**Basement Impact
Assessment Audit**

21 Baldwin's Gardens, London
EC1N 7UY

For
London Borough of Camden

Project No.
14006-24

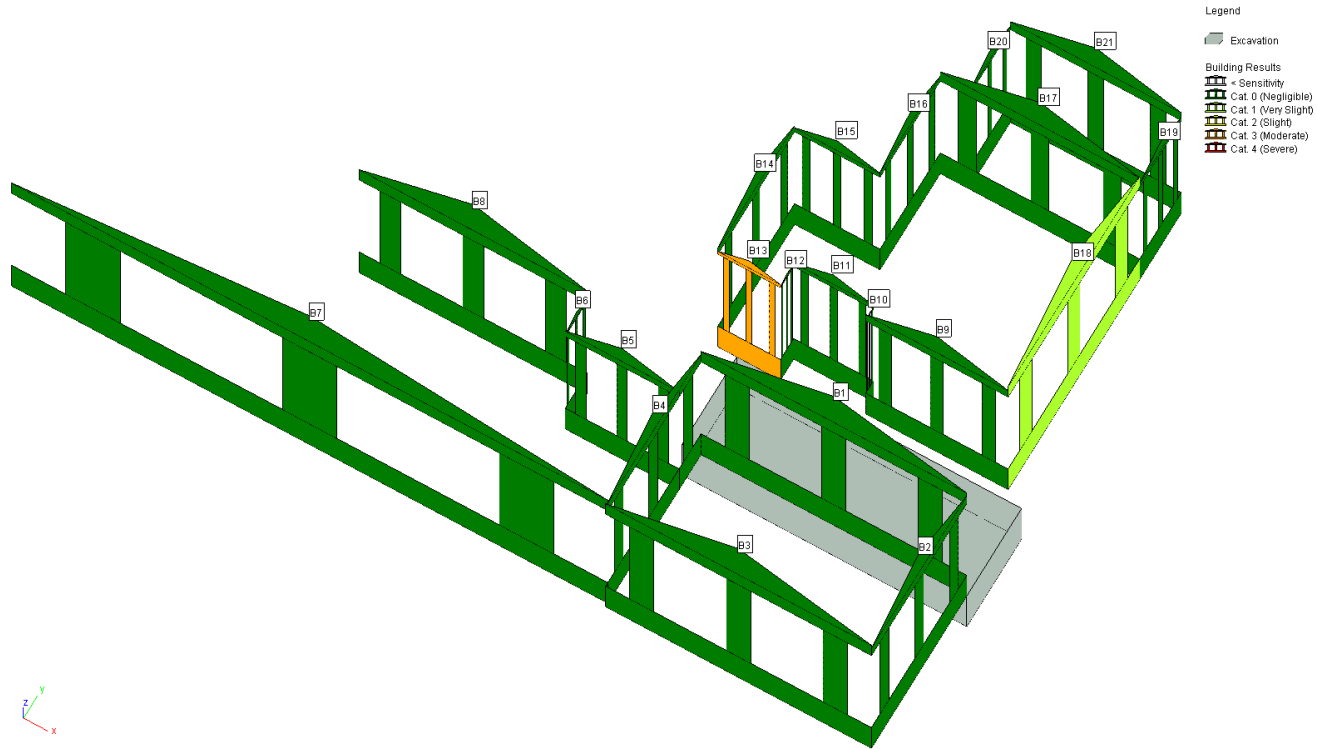
As you can see from the screenshot below, all walls were calculated to be Category 0 or Category 1 damage, before any combining of segments, apart from B13, which was calculated to be Category 3.

The wall is calculated to have been made up of 6 segments, summarised below:

- Segment 1: 1.834m long, and a damage category 0
- Segment 2: 0.249m long, and a damage category 0
- Segment 3: 0.425m long, and a damage category 3
- Segment 4: 0.195m long, and a damage category 0
- Segment 5: 0.252m long, and a damage category 0
- Segment 6: 0.344m long, and a damage category 0

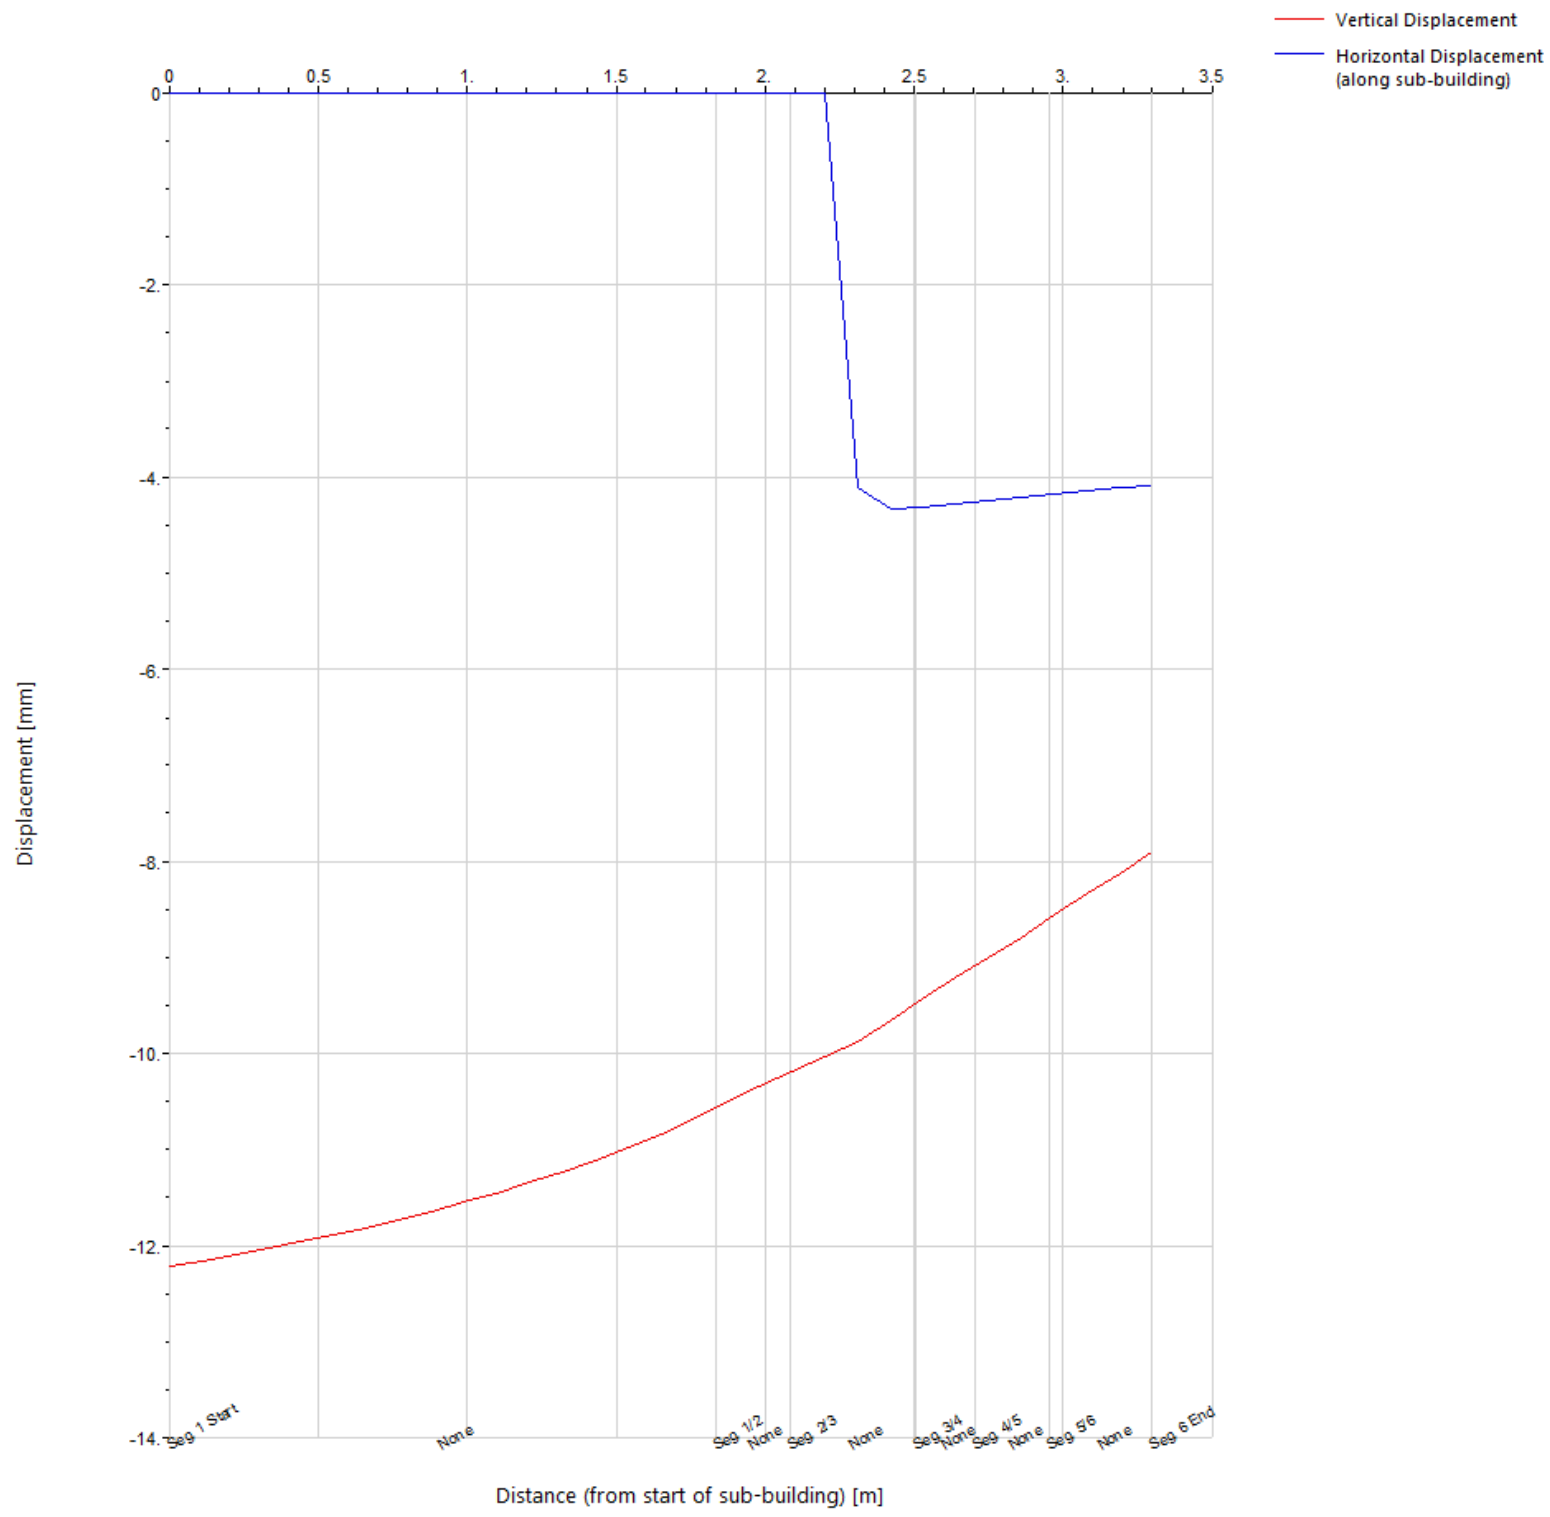
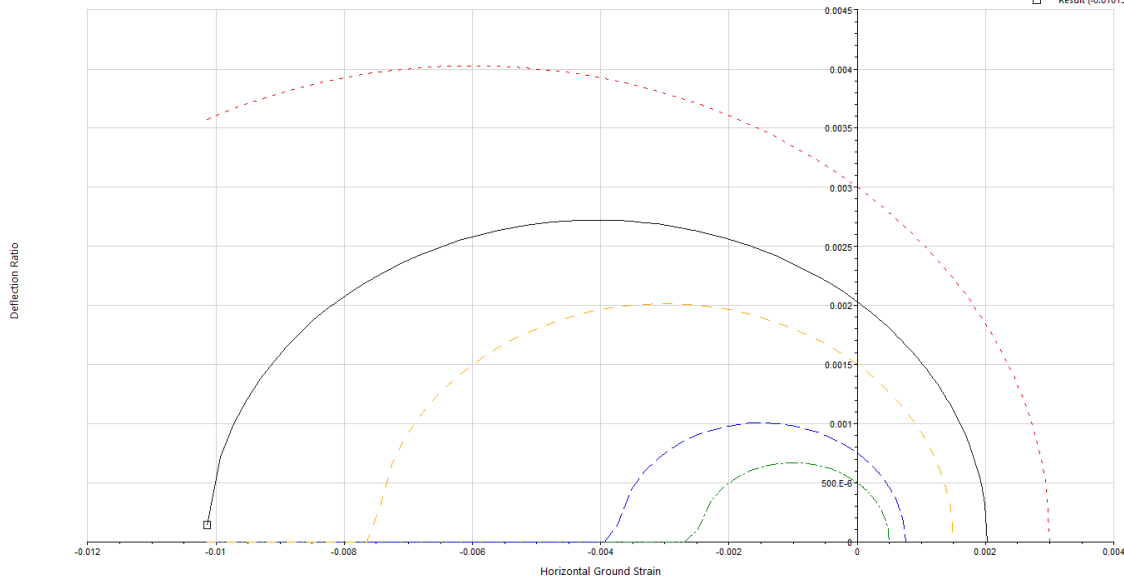
The soil displacement graph for B13 has been provided below, with each of the six segments also detailed. The graph shows that segment 3 is heavily influenced by an immediate change in the horizontal displacement. When the wall is running directly parallel and immediately adjacent to the proposed basement (i.e Segment 1 and 2), 0.00mm of horizontal displacement is calculated; however, when the wall starts extending beyond perpendicular the proposed basement, horizontal displacement is calculated immediately from 0.00mm to ~4.20mm (Segment 3), before decreasing uniformly (Segment 4 onwards).

Specifically for Segment 3, there is high amounts of horizontal strain, due to the immediate increase of horizontal soil displacement. The increase is from 0.00mm to ~4.20mm. The horizontal strain is calculated to be approximately -0.01, which is the main driver to place this segment into Category 3.

Given the unique geometry of the wall, with half of the wall running parallel/immediately adjacent to the basement and the second half running perpendicular to the basement, and generally each segment being less than 0.50m in length, the wall was considered more suitable to be assessed as one, and the segments were combined.
